Customer : CU-DAR001 Dart Helicopters Services Drawing Name : 350 SKIDTUBE ASSEMBLY RH
 Job Number : 41771
 Estimate Number : 10265
 P.O. Number :
 This Issue : 03/09/2008 S.O. No. :
 Prsht Rev. : NC
 First Issue : / / Type : SKIDTUBES
 Previous Run : 41770
 Part Number : D350636012
 Drawing Number : D2750 UNDER REVIEW + DSI 9413
 Project Number : N/A
 Drawing Revision : E
 Material :
 Due Date : 30/09/2008 Qty: 1 Um: Each
 Written By :
 Checked & Approved By : JLD 08.9.03
 Comment :
 Est Rev: I 02.09.25 Rearranged procedure steps KJ
 Est Rev: J 06-03-29 As per Rev D EC
 Est Rev: K 06-07.13 As per dsi9343 EC
 Est Rev: L 07-07-28 Added SS Wearplates (Rev E) JLM
 Verified By: EC
 Est Rev: M 08-04-22 update steps 4,13 DD verified by: EC

FIGURE 1 - WEARPLATE MODIFICATION

A	NEW ISSUE	PH	08.05.14
REV.	DESCRIPTION	BY	DATE
DESIGN	PH	DART AEROSPACE USA, INC PORT HADLOCK, WA	
DRAWN	PH		
CHECKED		DRAWING NO.	REV. A
MFG. APPR.	N/A	DSI 9413	SHEET 1 OF 3
APPROVED		TITLE	SCALE
DE APPR.		WEARSHOE MODIFICATION	NTS
DATE	08.05.14	<small>COPYRIGHT © 2008 BY DART AEROSPACE USA, INC THIS DOCUMENT IS PRIVATE AND CONFIDENTIAL AND IS SUPPLIED ON THE EXPRESS CONDITION THAT IT IS NOT TO BE USED FOR ANY PUR

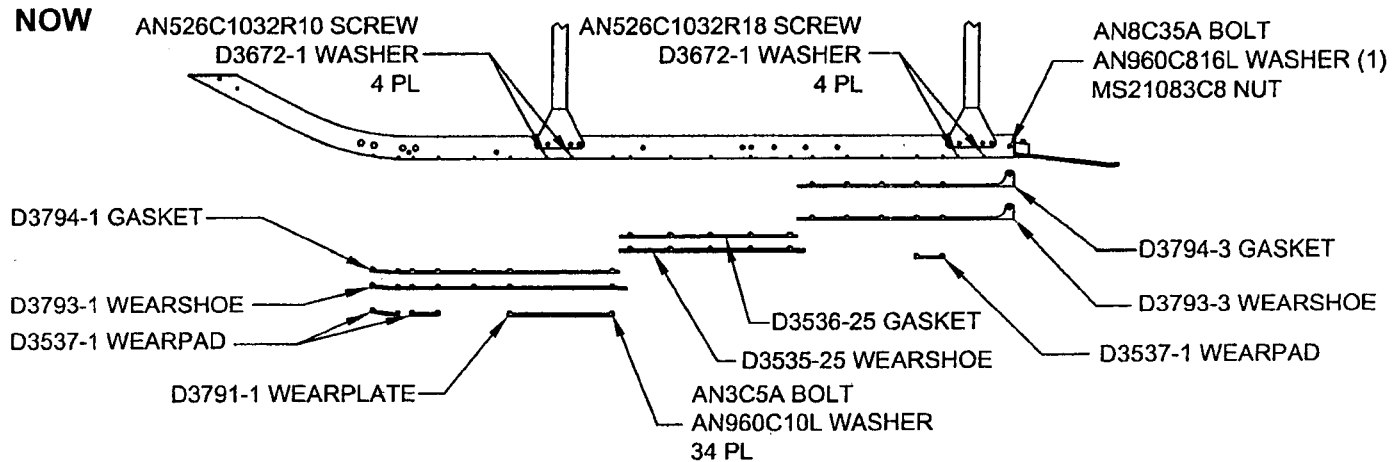
THE WEARPLATES ON D350-636-011/-012/-013/-014 SKIDTUBES AT CHG 004 (AND LATER) HAVE BEEN MODIFIED AS SHOWN IN FIGURE 1 BELOW TO ELIMINATE THE POSSIBILITY OF INTERFERENCE BETWEEN THE WEARPLATES AND CROSSTUBE SADDLES AT INSTALLATION. THERE IS NEGLIGIBLE WEIGHT CHANGE ASSOCIATED WITH THIS MODIFICATION.

(AN526C1032RXX SCREW LOCATIONS NO LONGER USED TO MOUNT WEARSHOES)

TO INSTALL THE DSI 9413-011 KIT, REMOVE THE EXISTING WEARSHOES/GASKETS UNDER THE FWD/AFT SADDLES AND INSTALL NEW WEARSHOES/GASKETS AS SHOWN IN FIGURE 1. PLUG UNUSED HOLES WITH AN526C1032RXX SCREWS AND D3672-1 WASHERS. INSTALL SCREWS WITH SIKAFLEX -241/-291 OR PROSEAL 890 OR MIL-S-8802 CLASS 'B2' SEALANT AS SHOWN IN FIGURE 1. NOTE: SOME OF THE PREVIOUSLY INSTALLED HARDWARE IS NO LONGER REQUIRED.
